**[A] Comment #106 - Proposed Draft Text****142.2.2.2.6 Differential Encoder [Comment**

**[B] Comment #107 - Proposed Draft Text****142.2.3.1 Differential Decoder (or possibly in CL 142.2.3.2 since this function is for the ONU)**

Figure X

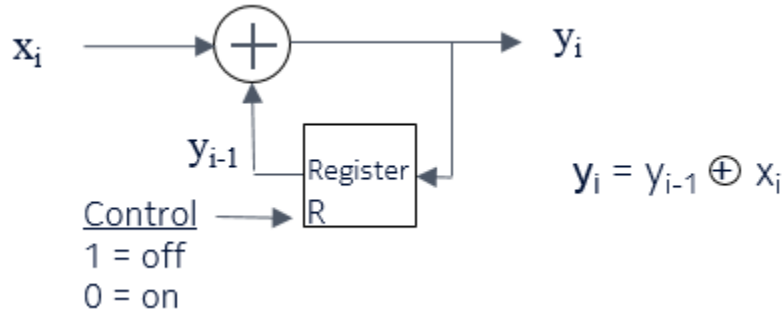
Differential encoding as shown in Fig. X shall be implemented in the OLT TX PCS for downstream.

A control bit shall be added to be able to disable the differential encoding function via SW provisioning.

Figure Y

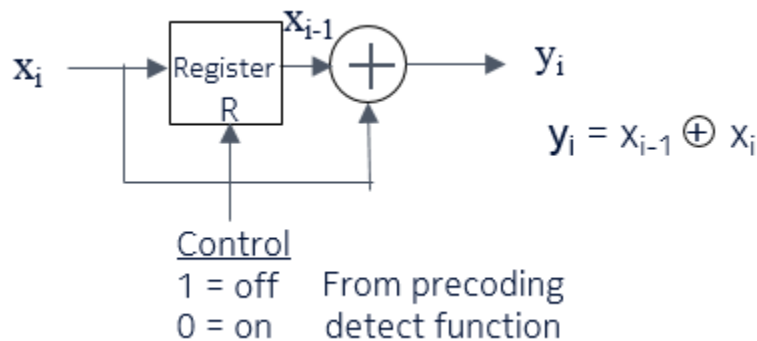
Differential decoding shall be implemented in the ONU PCS RX function as shown in Figure Y

The ONU shall implement automatic detection of RX path differential encoding, and switch the decoder in appropriately.
